AGENDA

PLANNING AND ZONING COMMISSION

JANUARY 16, 2020

PLAT OF
ODESSA HOLDINGS 1 PARK

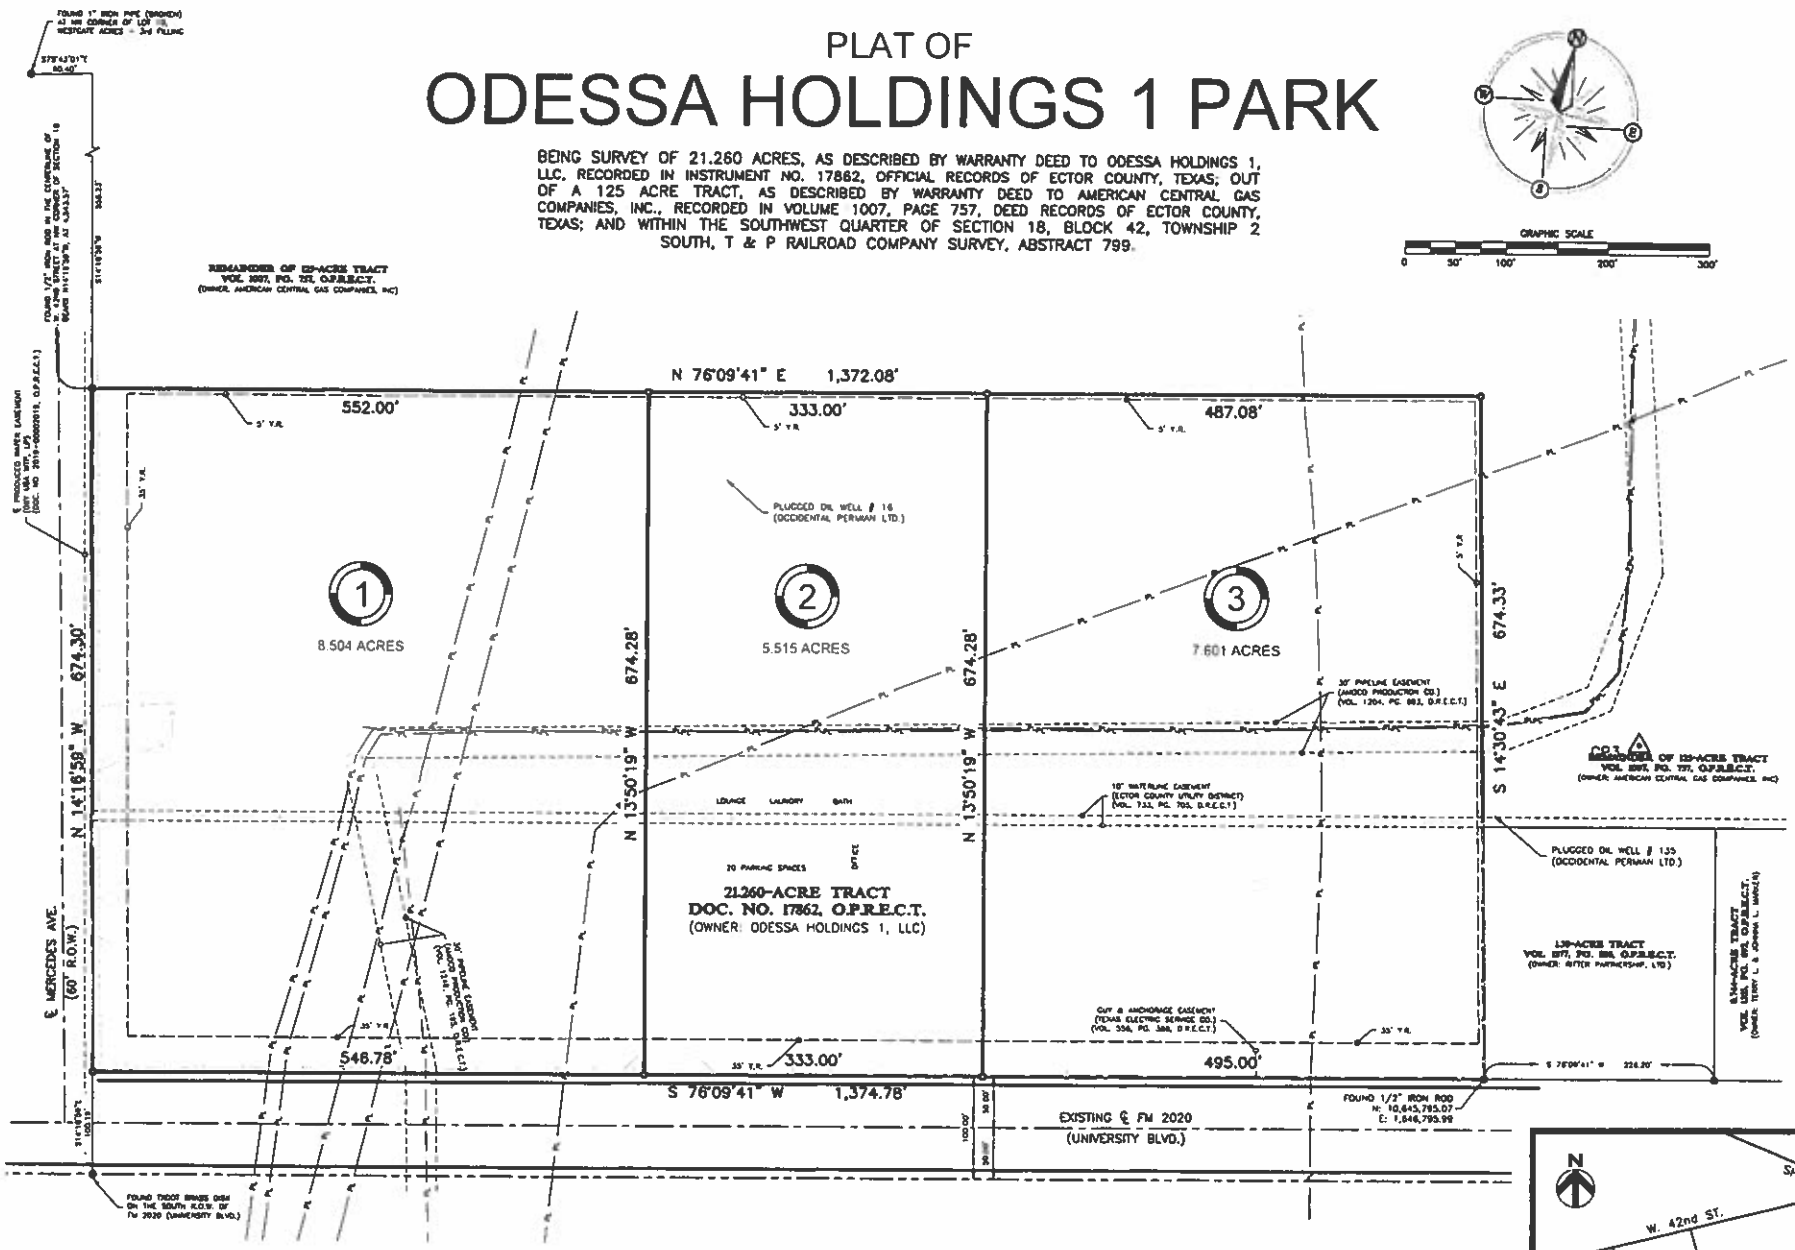
-- Original tax certificates need to be submitted prior to filing the plat.

-- Water is available thru ECUD. No sewer available.

-- Drainage report needs to be submitted. Drainage plan needs to address detention requirements. This tract is not in a special flood hazard area.

-- Various easements and pipelines noted on the plat need to be dimensioned.

-- Access Easement need to be provided for oil field use.

-- Access to the sites should be managed in accordance with current TxDOT Access Management Standards. For this section of roadway, the posted speed limit is 55 mph and minimum spacing requirement between access points both existing and proposed is 425'. The sites may need to utilize shared access to provide access to all 3 lots. Post-development runoff should not be increased from pre-development conditions. (TXDOT)

1. Blanket refuse collection easement and access easement for oilfield use is needed (Public Works/Planning)

2. Dedicate a 20' cutback at University and Mercedes. (Public Works)
